Appln. No. 09/825,910
Amdt. dated Mar.24, 2004
Reply to Office communication of Sep. 24, 2002
Docket 14XZ00098

Remarks/Arguments

FIG. 4

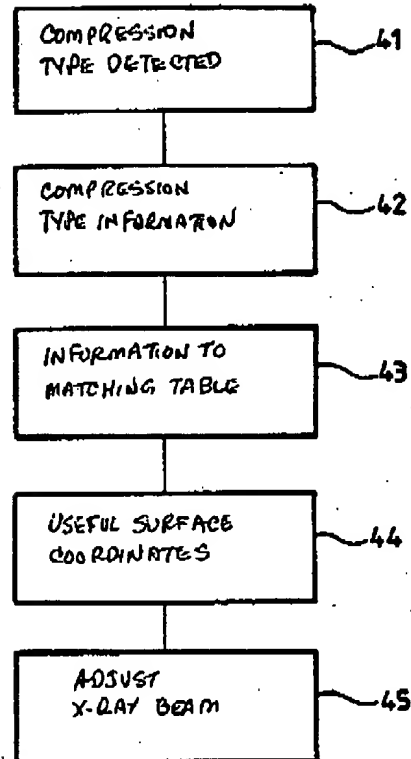
In response to the drawing requirement, Figs. 4 and 5 have been amended to show the legends for the block symbols.

LEGENDS ADDED
TO BLOCK SYMBOLS
